The Alaskan Way Viaduct & Seawall Replacement Program

A Retrofit is Not Enough

Review of Retrofit Proposal

Rendering of retrofit proposal for area under the viaduct.

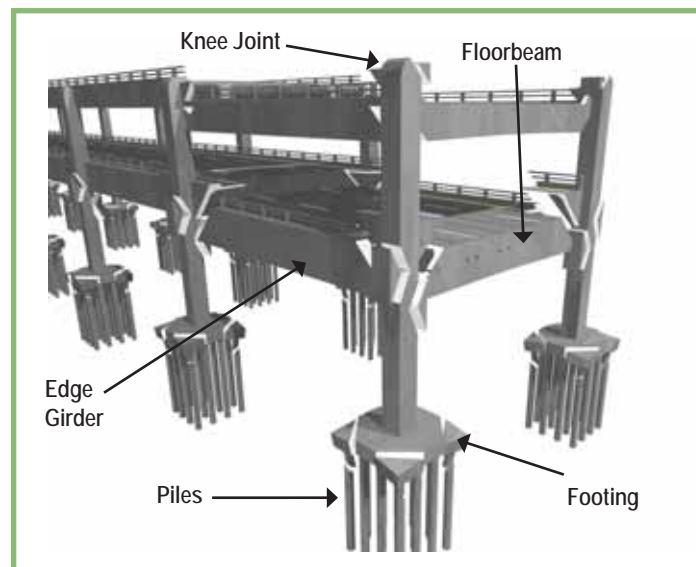
- Installation of steel strengthening frames running crosswise and lengthwise at the middle columns and bays of each viaduct section. The proposal did not include specific dimensions for these pieces of steel so T.Y. Lin International estimated the appropriate sizes.

- Wrapping of steel jackets around the base of some of the columns to provide additional strength to the structure. T.Y. Lin International believed these jackets would be required for all of the columns and so added them to the proposal.

- Placing of shock absorbers within the middle bay of the viaduct. Additional shock absorbers were shown between adjacent sections to prevent them from banging into each other during an earthquake. Because the evaluation looked at one section of the viaduct, these were not included. However, T.Y. Lin International concluded that these shock absorbers may serve to "lock" the sections together, synchronizing the movement of each section together.

- Ground improvements were included, but soil improvements were not explicitly included in the evaluation. T.Y. Lin International observed that these improvements may adversely affect the movement of the foundations.

Shown in red is the expected damage for the design for 500-year earthquake.

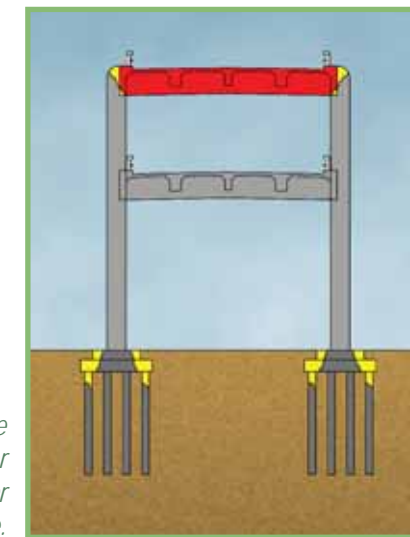
The viaduct has many weak points that could cause it to collapse in a very bad earthquake.

- The **footings** of the viaduct would be subject to higher shear and flexural demands, and higher joint shears than for the bad earthquake. Severe damage of the footings is likely.
- The **piles** would be subject to higher compressive forces that cause severe damage to the footings.

- The **columns** will rock on the pilings, which they were not designed to do. This rocking may result in severe impacts to the adjacent viaduct sections. The columns are very brittle and the loads from the rocking plus the damage to the footings would likely cause the viaduct to collapse.
- Other parts of the viaduct will also be severely damaged and could fail. For example, the **floorbeams** will suffer from negative bending at the connection with the columns. **The knee joints** – some of which failed in the Nisqually earthquake – could also fail.

- The footings of the viaduct require a retrofit.
- The lower floor beam / column joints need to be strengthened.
- The joints between the columns and upper floor beams need to be replaced.
